Part Change Notification:

A7A-USB2C-1-B
A7B-USB1C-1-B
A7B-USB2C-1-B
A8-USB2-1-B-4.8A-T
A8-USB2-1-B-4.8A
A8-USB2-1-BN-4.8A
A8-USB1-1-BN-2.4A
A6-USB2C-1-B

1. Finished Product Appearance Change:

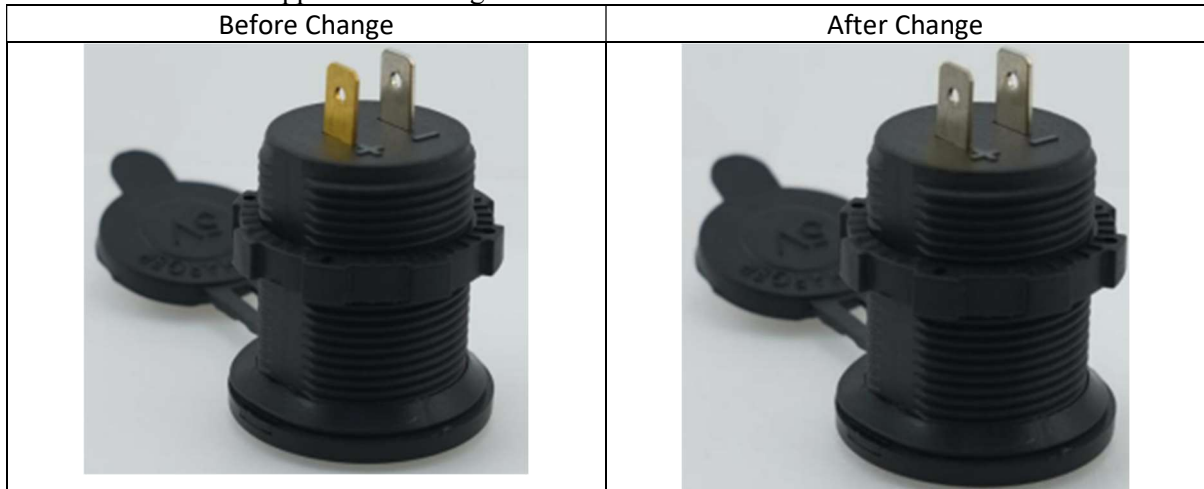
Both terminals will now be provided with nickel plating. Previously only the negative terminal had such plating. This change will improve corrosion resistance of the part. During a 200hr salt spray test, the terminal without plating experienced significantly more corrosion. By including the plating on both terminals, the corrosion resistance of the part will be increased without negatively impacting the functionality.
